MFN 06-298

**Subject: Response to Portion of NRC Request for Additional Information  
Letter No. 38 Related to ESBWR Design Certification Application –  
Structural Analysis - RAI Numbers 3.8-1, 3.8-2, 3.8-4, 3.8-5, 3.8-7  
through 3.8-12, 3.8-15, 3.8-16, 3.8-21, 3.8-22, 3.8-29 through 3.8-31,  
3.8-39, 3.8-42, 3.8-43, 3.8-45, 3.8-50, 3.8-52 through 3.8-55, 3.8-57,  
3.8-58, 3.8-60, 3.8-61, 3.8-66 through 3.8-68, 3.8-70 through 3.8-72,  
3.8-74, 3.8-75, 3.8-78, and 3.8-98**

**Response to Portion of NRC Request for  
Additional Information Letter No. 38  
Related to ESBWR Design Certification Application  
Structural Analysis**

**Figure 3.8-29(1) High Secondary Stress Portion due to  $T_a = 171^\circ\text{C}$**

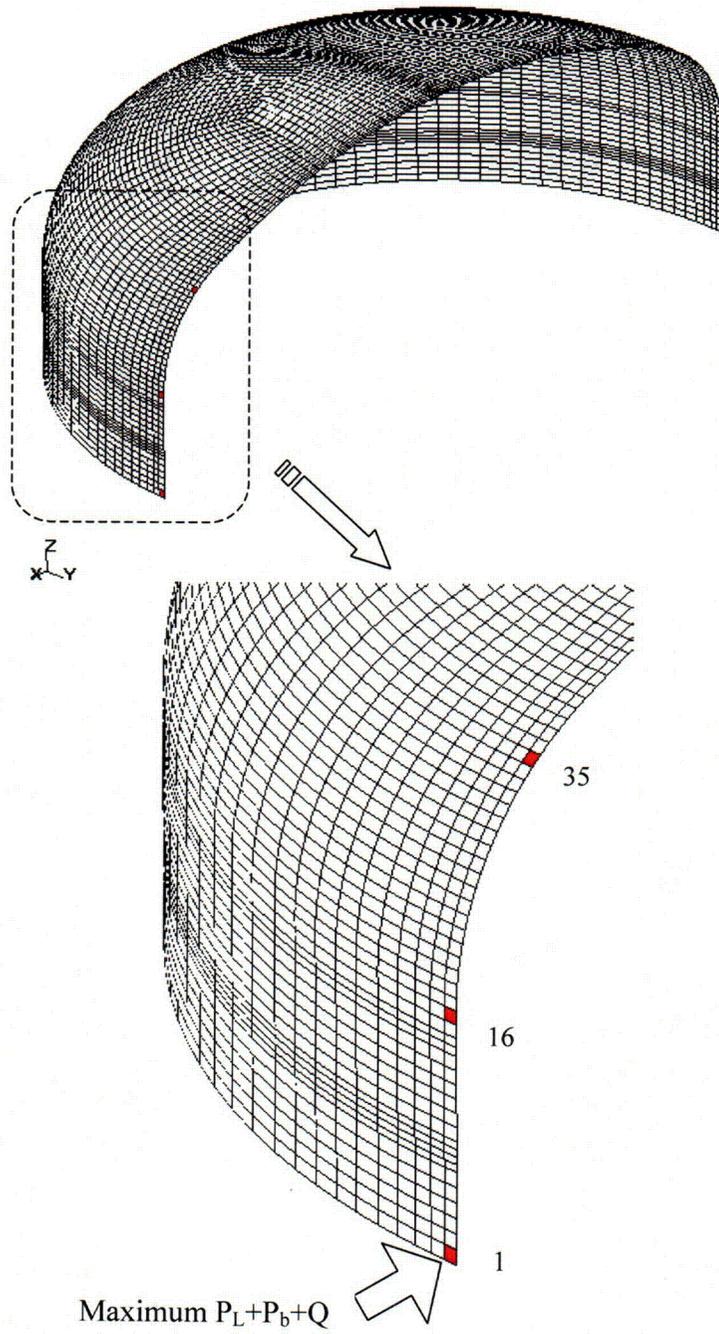
*DCD Table 3G.1-36 identifies that the Service Level A, B primary + secondary stress condition in the drywell head exceeds the basic code allowable stress by 75% ( $P_L+P_b+Q$  is 794 MPa calculated vs. 456 MPa allowable). Describe in detail and pictorially the geometry/location of all overstress conditions. Explain why  $Q$  is 11 times greater than  $P_L+P_b$ . Identify the loading condition(s) that created this overstress condition (pressure loads, thermal loads, or a combination). Provide the technical basis for relying on the NE-3228.3 analysis to show acceptability, rather than implementing a design modification to alleviate the high secondary stress. Provide the details of the NE-3228.3 analysis. Include this information in DCD Section 3.8.2 and/or Appendix 3G.*

The high stress value is due to thermal loads from the LOCA condition. Since the DW head is fixed at the cylindrical part to the concrete slab, high discontinuity stresses are present at the joint. This is secondary stress and cannot be alleviated by design modification. The portion where the high stress occurs is shown in Figure 3.8-29(1).  $P_L+P_b$  is the primary membrane stress so it does not include thermal stress, and the stress value is at the center of the plate thickness, while  $P_L+P_b+Q$  is the primary plus secondary stress including thermal stress, and the stress value is at the surface of the plate. Therefore,  $P_L+P_b+Q$  is much higher than  $P_L+P_b$ . Under this type of secondary stress, the ASME permits a simplified elasto-plastic analysis in NE-3228.3. The details of the NE-3228.3 analysis will be included in DCD Section 3G.1.5.4.1.4 in the next DCD revision as noted in the attached markup.
